BELLWOOD DAM

NDI ID. No. PA - 00524

PHASE I INSPECTION REPORT
NATIONAL DAM INSPECTION PROGRAM

PREPARED BY
GAI CONSULTANTS, INC.
570 BEATTY ROAD
MONROEVILLE, PENNSYLVANIA 15146
JUNE 1979

FIGURE 1 - BELLWOOD DAM
GENERAL PLAN
FIELD INSPECTION NOTES

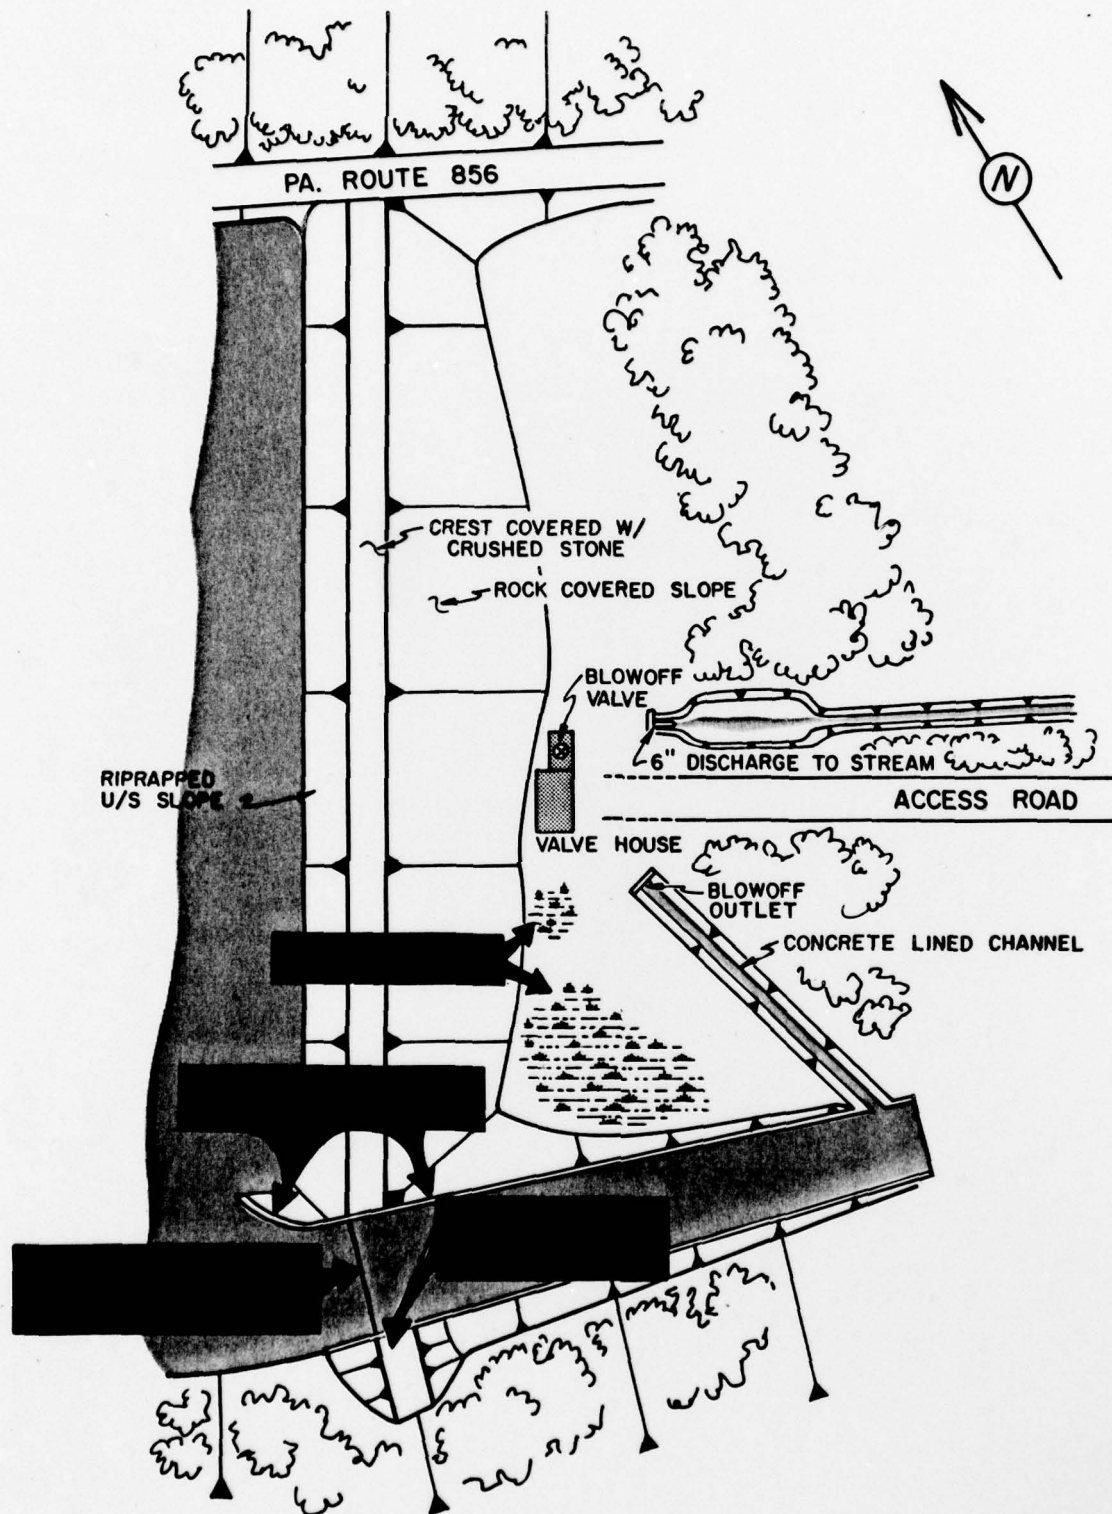
b. Embankment. The visual inspection indicates that the embankment is in good condition and well maintained. Two wet areas were observed below the downstream toe between the spillway and gate house. The smaller of the two areas (about 2 to 3 feet in diameter) is located about 140 feet to the left of the gate house. The larger area is triangular shaped (40 by 100 feet) located adjacent the toe of the embankment and spillway wall slopes (see Photograph 9). No measureable flow was observed in either area. A rough survey performed during the field inspection indicates that the short embankment section to the right (west) of the spillway is approximately 0.9 foot below the design top of dam and thus reduces the effective spillway capacity.

Deficiencies associated with the facility include:
1) minor settlements across the embankment crest; 2) joint spalls in the channel walls and crest of the spillway; 3) wet areas located immediately beyond the downstream embankment toe between the gate house and spillway; and 4) lack of a means of flow control at the inlet ends of the outlet conduits.

a. Have the embankment crest accurately surveyed and infill any low spots to restore the crest to the design elevation 1366.0 feet.

d. Observe the wet areas located immediately below the downstream toe between the gate house and spillway and address them in future inspection reports.
